Robert M. Nelson, Jr.
October 18, 1991
91-RF-6769
Page 2

U.S. DEPARTMENT OF ENERGY
 Rocky Flats Plant, Golden, Colorado
 OPERABLE UNIT NO. 1
 PHASE III RFI/RI WORK PLAN
**PROPOSED PHASE III RFI/RI
 SURFACE WATER, MONITOR WELL,
 BOREHOLE, PIEZOMETER, AND SEDIMENT
 STATION LOCATIONS**
 FIGURE 1
 August 1991

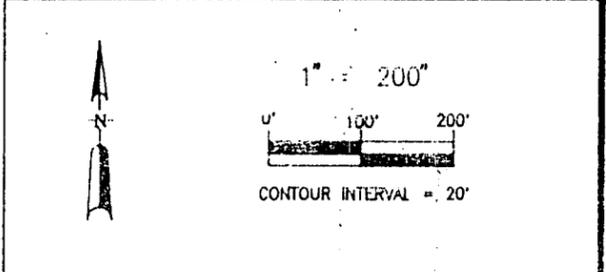
The other OU 1 issues to be relayed at this time concern the field activities. A few of the drilling locations proposed for this Phase III field program fall within the limits of the french drain excavation, which is expected to begin this month. BH01/MW01 and BH02, located to provide characterization of IHSS 102, are in conflict with the french drain excavation. The suggested solution is to continue with the boreholes (quickly) to gather some characterization data, but cancel the monitor well installation as the well would need to be abandoned within one month of installation. EPA and CDH concurrence on this solution is requested.

An additional repercussion of the french drain excavation is that several existing sampling stations providing data to the OU 1 RI will be destroyed or abandoned. The list of these sites is as follows: SW-45, SW-46, SW-126, MW3-87, MW 59-86R, MW 8-87, SW-125, SED-125, SED-126, MW 59-86 and MW2-87. The only solution to this situation is to continue to accumulate as much data as possible from these sites before excavation begins.

abandoned due to site geologic conditions. Alluvial wells were proposed but could not be installed because the shallow depth to bedrock did not allow the proper footage required for well installation. For example, MW 33 encountered bedrock at 5.1 feet. The Standard Operating Procedure (SOP) requires a 3-foot bentonite seal and a 2-foot filter (sand) pack as minimums above the screen. Even with a 2-foot screen, this well could not be installed within these guidelines. The list of proposed wells that have been abandoned to date under this scenario includes: MW33, MW32, MW31, MW28, MW27 and MW25.

Another field adjustment is that some of the proposed sites were not accessible by a drill rig. Most of these sites required minor (10 feet) relocation but are still able to meet the objectives of the proposed location. One proposed borehole, BH 15, could not be relocated due to accessibility. This proposed location just south of the 881 Building is extremely steep and every potential access is blocked by security fences, power lines or overhead process lines. Relocation of more than a few feet placed this hole within a few feet of another boring, since tight coverage in this area was already proposed.
